ECN/PCN No.: M1096

For Manufacturer		
Product Description: 10/100Base-TX RJ45, Tab UP, LED	Abracon Part Number / Part Series: ARJC01-111002T	<input type="checkbox"/> Series <input checked="" type="checkbox"/> Part Number
Affected Revision: A	New Revision: B	Application: <input type="checkbox"/> Safety <input checked="" type="checkbox"/> Non-Safety

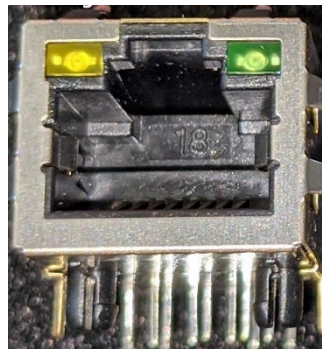
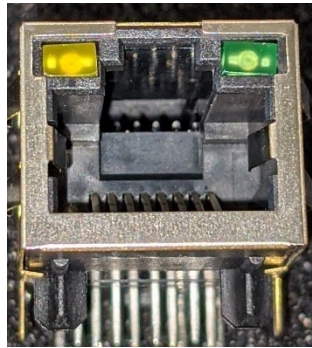
Cosmetic Differences

Front (Faceplate) - Front faceplate and LEDs of the original production line.

Part Marking - Marking appears on the back-side of the device and marked using ink. (part number shown is for illustration only).

EMI Fingers - fingertips flare outward from body.

Board Guides - round board guides

Cosmetic Differences

Front faceplate and LEDs of the new production line. LED lenses are slightly more diffused than original production line. This may cause slight variations in luminosity.

Part Marking - Part number will appear on top of device and laser marked (part number shown is for illustration only).

EMI Fingers - fingertips flare inward towards body.

Board Guides - Star board guides

Standard product review. Increased manufacturing lines to support volume.

The changes described here do not negatively impact form, fit or function of the device. Device outline, mechanical dimensions, internal schematic and electrical performance remain identical.
